Environmental Statement Note on Increased Pylon Height within Bristol Port, Avonmouth

Hinkley Point C Connection Project

VOLUME 5.34.1 – INCREASED PYLON HEIGHT WITHIN BRISTOL PORT, AVONMOUTH

Document Control			
Document Properties			
Organisation	National Grid		
Author	Chris Slater, TEP		
Approved By	Bobby Clayton, TEP		
Title	Increased Pylon Height within Bristol Port, Avonmouth		
Document Reference	Volume 5.34.1		
Date	Version	Status	Description/Changes
01/06/2015	A	Live	New document for submission to PINS

Figure 1 – Site Location Plan of Pylons LD109 to LD113

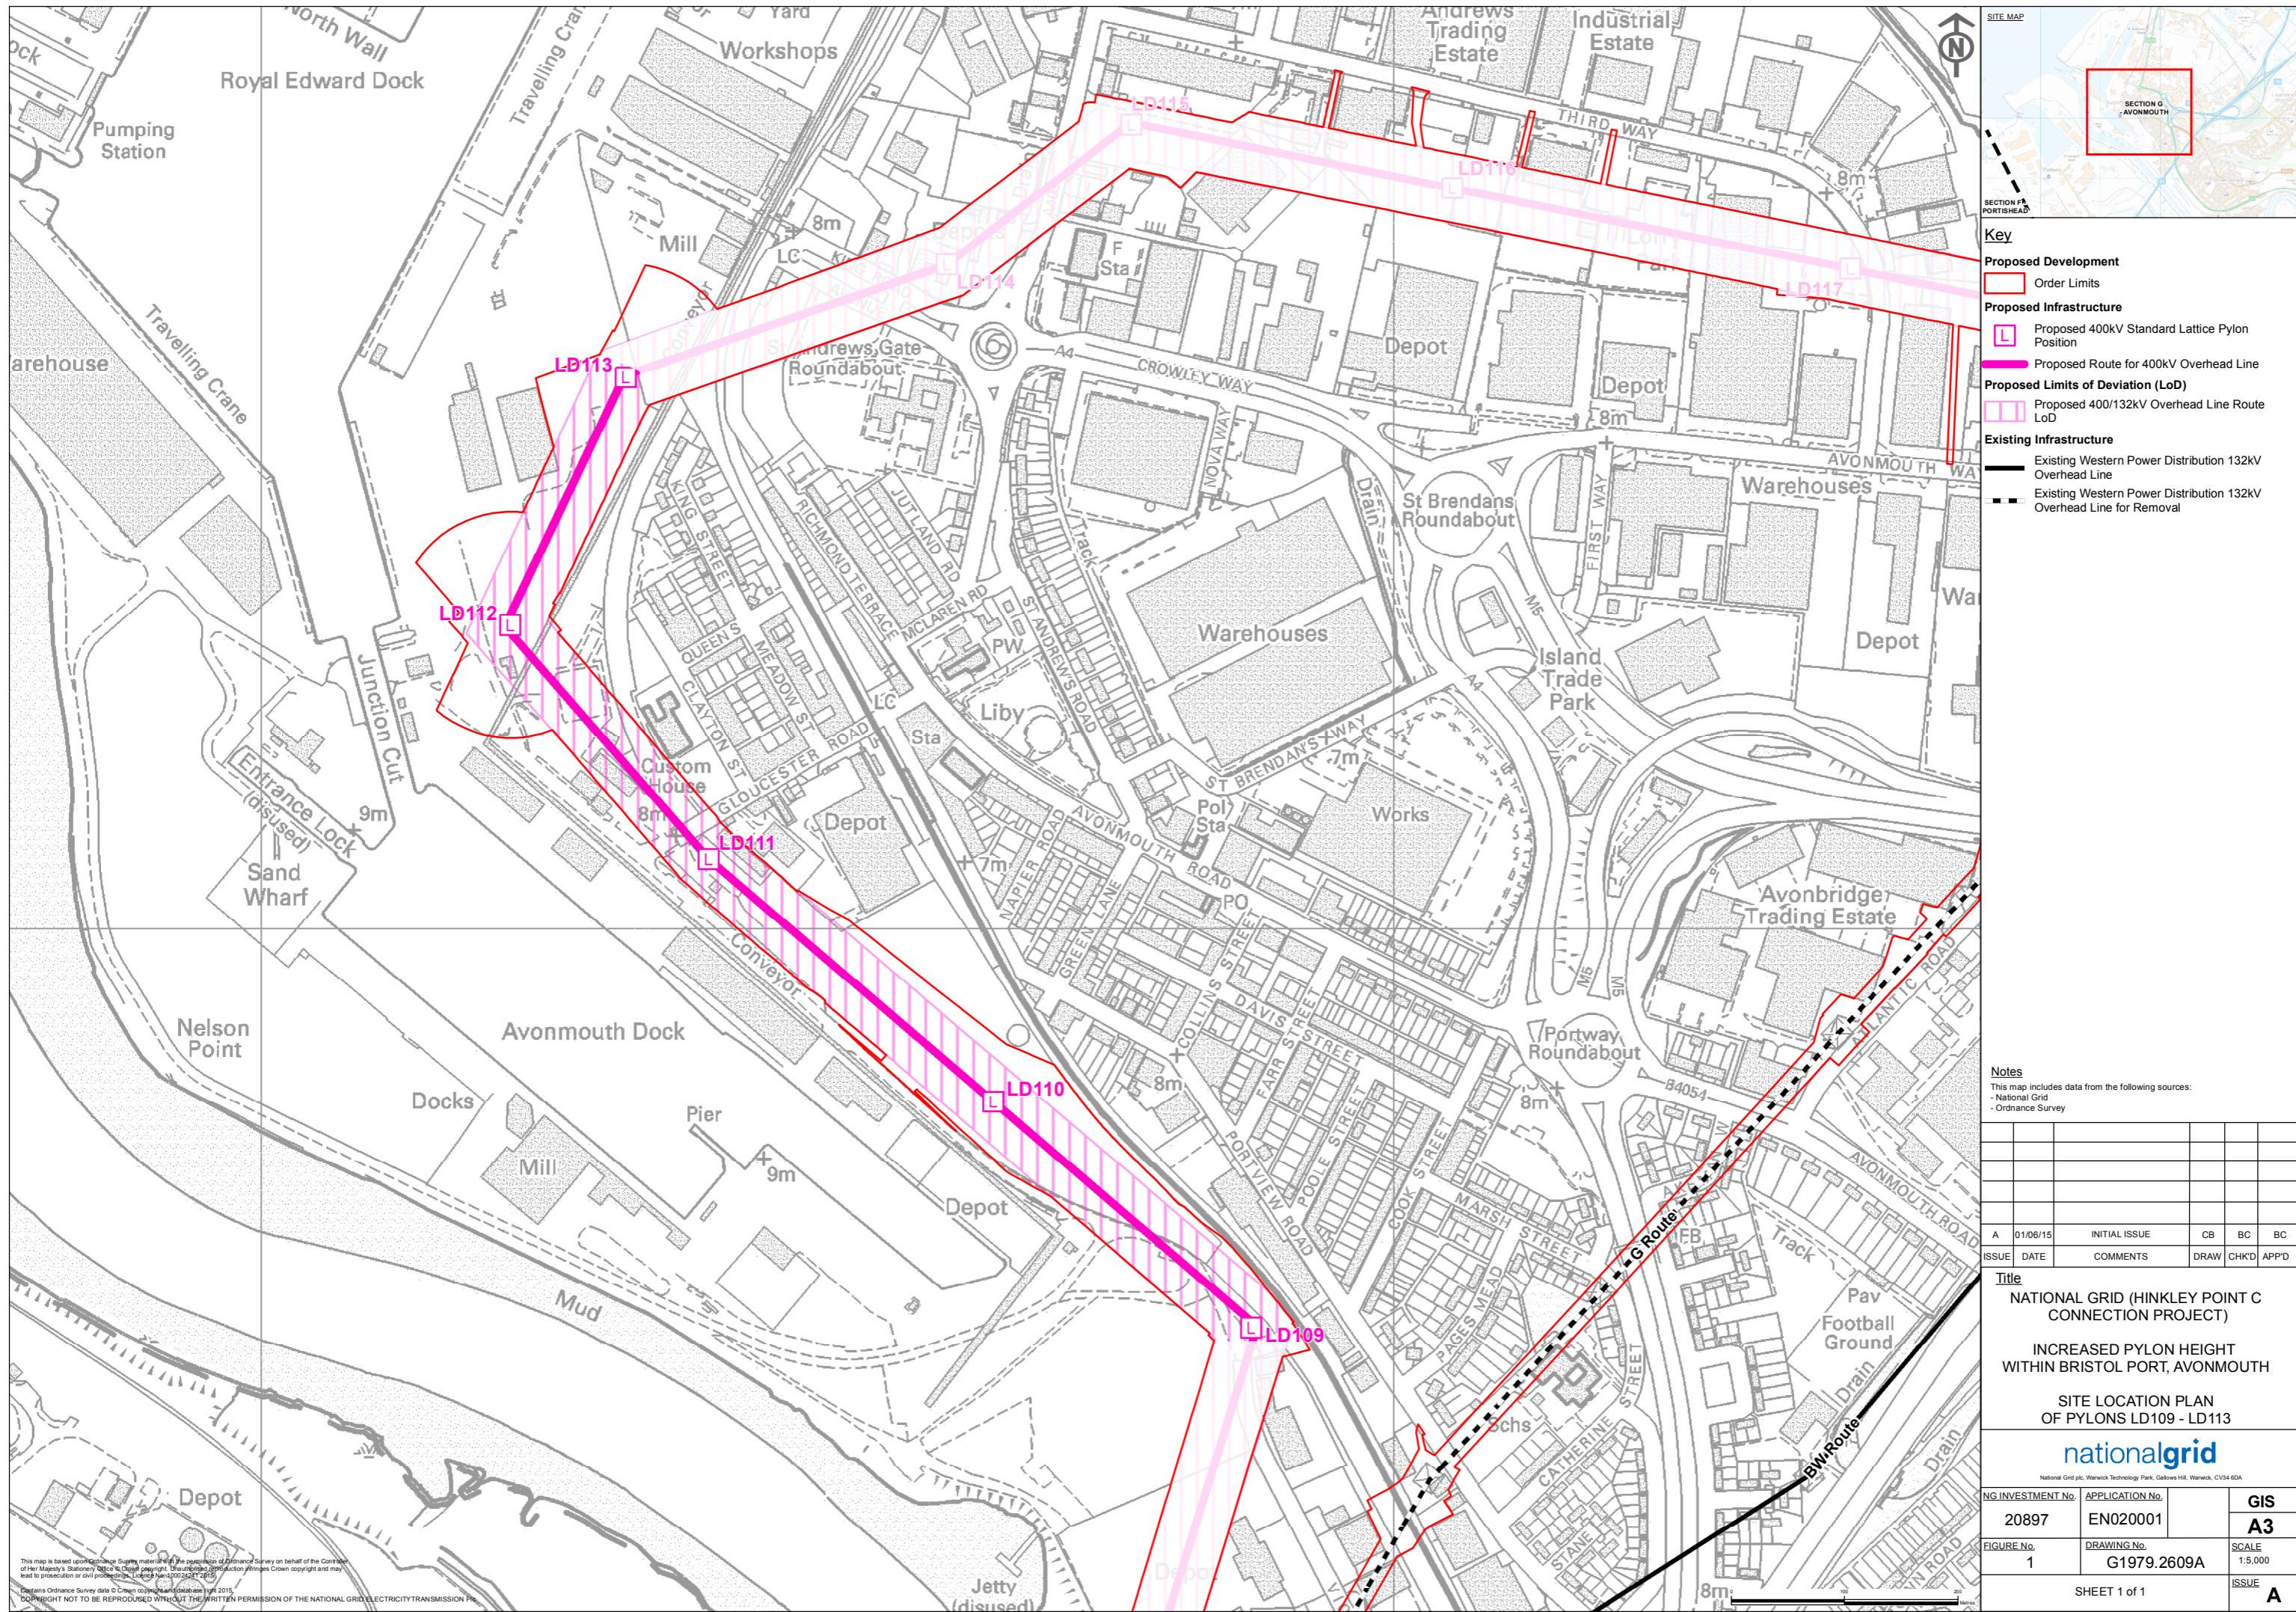
1.3.1 To achieve the required ground clearances within Bristol Port, pylons LD109 to LD113 are proposed to change in structure type and increase in height between 3m and 15m above what is currently proposed in the DCO and assessed in the ES. The location of pylons LD109 to LD113 is shown at **Figure 1**; the proposed pylon changes are shown in **Table 1** below.

HINKLEY C CONNECTION PROJECT
TOWER LD109
COMPARATIVE OUTLINES

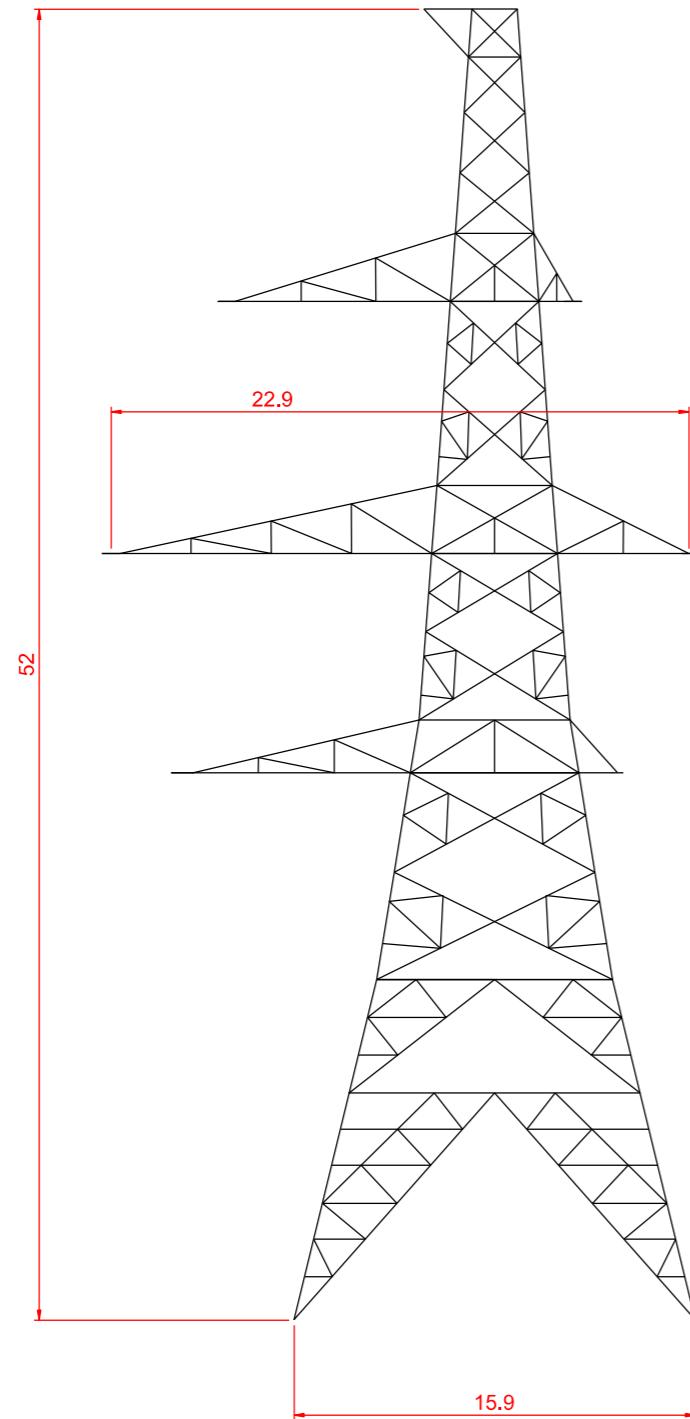
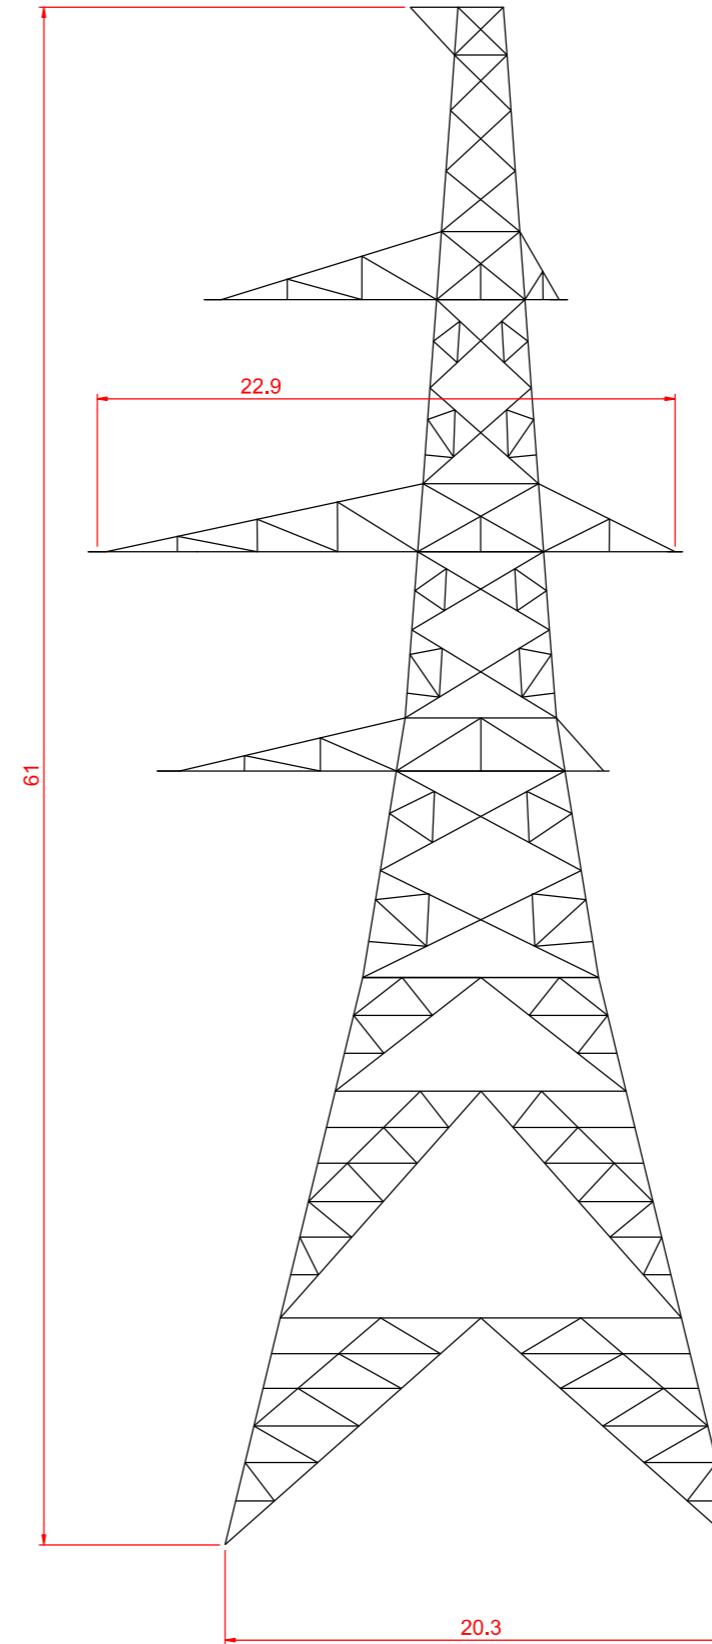
As Proposed in the DCO			Proposed Changes in this Document			
Pylon Number	Overall Height (m)*	Base Size (m)	Overall Height (m)	Height Increase over DCO (m)	Base Size (m)	Base Size Increase Over DCO (m)
LD109	52	15.92	61	9	20.3	4.38
LD110	46.5	7.05	61.5	15	10.51	3.46
LD111	51.3	9.06	60.3	9	11.37	2.31
LD112	52	15.92	61	9	20.3	4.38
LD113	51.85	13.32	54.85	3	14.52	1.2

1.3.2 The ES assessed pylon heights between 46.5m to 52m (detailed at **Table 1**), plus a vertical Limit of Deviation (LoD) of +/-4m (see **ES Volume 5.5, paragraphs 5.6.37-5.6.47**). **Figure 2** of this document provides a comparison of the profiles of the DCO and revised pylon types.

HINKLEY C CONNECTION PROJECT
TOWER LD110
COMPARATIVE OUTLINES

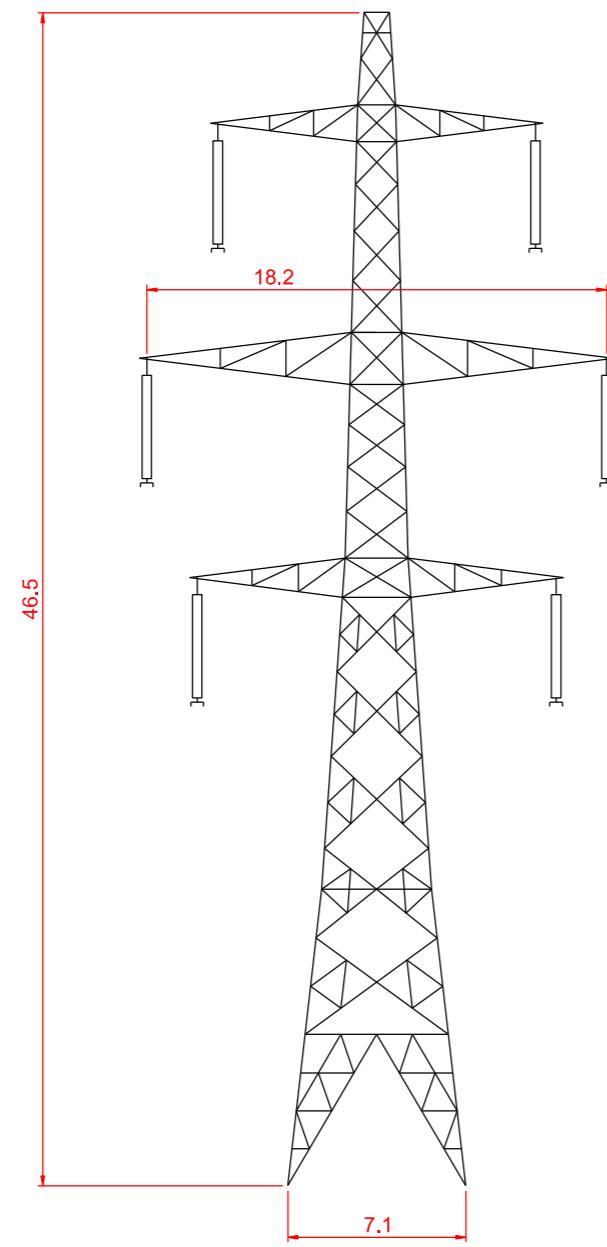
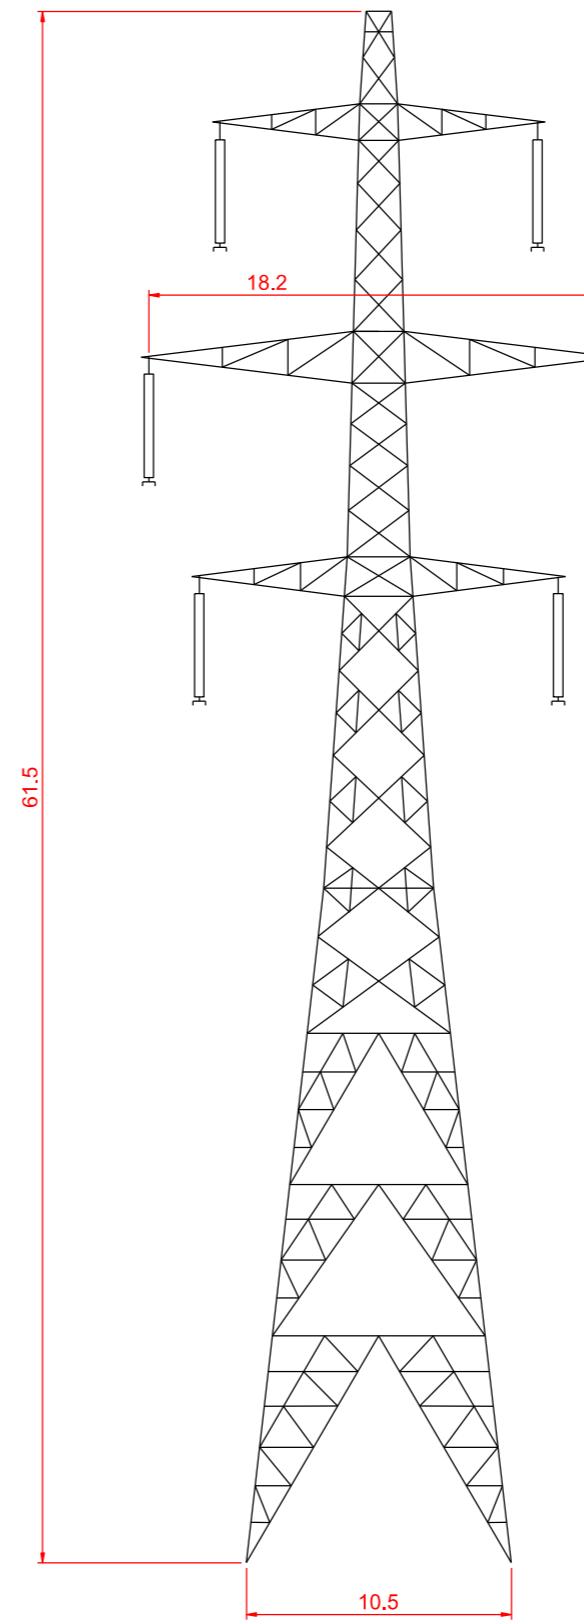
- 5.1.1 The proposed changes to the base size of the pylons would not affect the findings of the ES.
- 5.1.2 The proposed change in the height of pylons LD110 and LD111 will result in five trees (ID 443, 446, 450, 456 & 475) no longer requiring felling, instead being managed by pruning. This would be a beneficial effect.
